02 Independent Quality Assurance: Frame Inspection

[REDACTED]

[REDACTED] 2023

Single storey
Suspended slab
Timber frame
Sheet roof
Brick Veneer
Rendered brickwork
Lightweight cladding

Photo 8

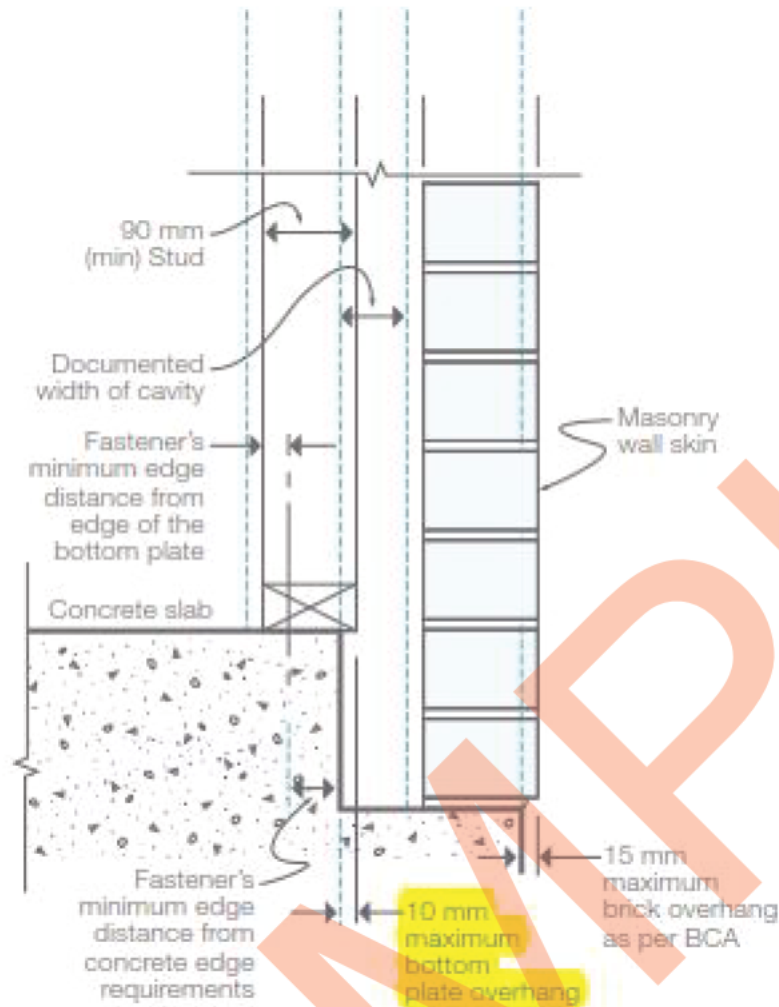
The highlighted recessed slab section have been grouted over and overhang appears to be greater than 20mm, engineer to review

As per the VBA's Guide to Standards and Tolerances section 4.08: "Bottom plates that are 90 mm wide or greater and overhang concrete slabs by more than 10 mm are defective."

Photo 22

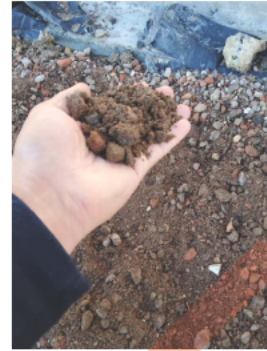
Loose Refer installed to perimeter of dwelling.

"Surface drainage shall be designed and constructed to avoid water ponding against or near the footing. The ground in the immediate vicinity of the perimeter footing, including the ground uphill from the slab on cut-and-fill sites, shall be graded to fall 50 mm minimum away from the footing over a distance of 1 m and shaped to prevent ponding of water. Where filling is placed adjacent to the building, the filling shall be compacted and graded to ensure drainage of water away from the building."

Photo 57

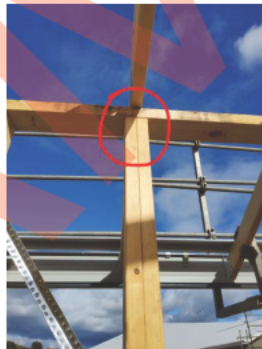
Top plate damaged at girder truss load point.

Photo 62

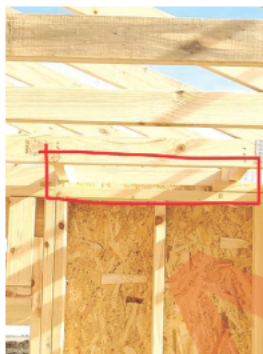
The highlighted living/outdoor living sheet brace/wall has not been provided with the required clearance to the plaster trimmers, this wall is a non load bearing wall.

Photo 76

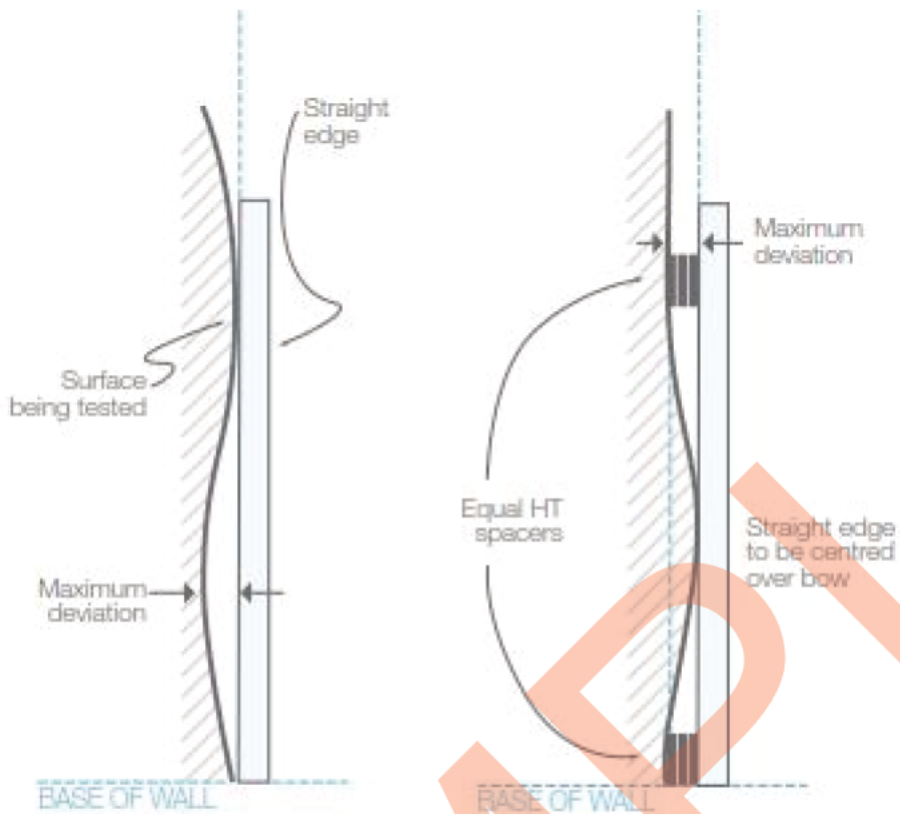
As per the VBA's Guide to Standards and Tolerances section 4.03: "Frames are defective if they deviate from plane (horizontal or vertical bow) by more than 4 mm in any 2 m length of wall."

Photo 79

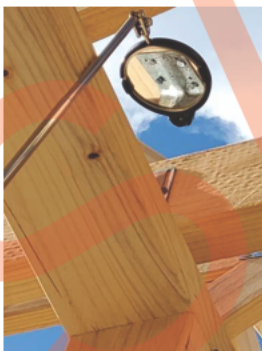
The nails used for the Lbrackets into the top plates are not the proprietary mitek nails and not as per manufacturers specifications
